# Technical Service Bulletin

SUBJECT:			No: <b>TSB-19-52A-004</b>
<b>EXCESSIVE INTERMITTENT MOVEMENT IN DRIVER'S POWER SEAT - REVISED</b>			DATE: <b>October 2019</b>
			MODEL: <b>2007-19 Outlander, 2018-19 Outlander PHEV, 2011-19 Outlander Sport/RVR</b>
CIRCULATE TO:	<input type="checkbox"/> GENERAL MANAGER	<input checked="" type="checkbox"/> PARTS MANAGER	<input checked="" type="checkbox"/> TECHNICIAN
<input checked="" type="checkbox"/> SERVICE ADVISOR	<input checked="" type="checkbox"/> SERVICE MANAGER	<input checked="" type="checkbox"/> WARRANTY PROCESSOR	<input type="checkbox"/> SALES MANAGER

*This bulletin supersedes TSB-17-52A-003, issued May, 2017, to add Outlander PHEV and additional model years for Outlander and Outlander Sport, and to update parts and procedures to help resolve the power seat movement. Revisions are italicized and indicated by ◀.*

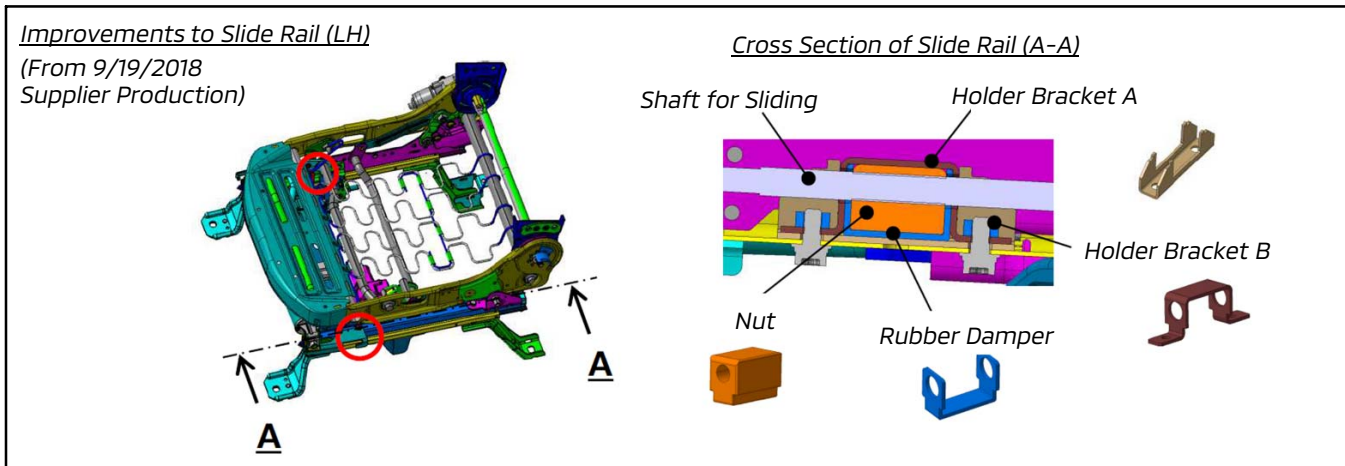
- ▶ Height adjustment linkages in the seat adjuster assembly may loosen over time with normal driving and allow movement. A new seat adjuster was implemented in production at the supplier from March 2, 2016, and has added metal bushings at the 6 rotational connections on the seat frame, as shown below.
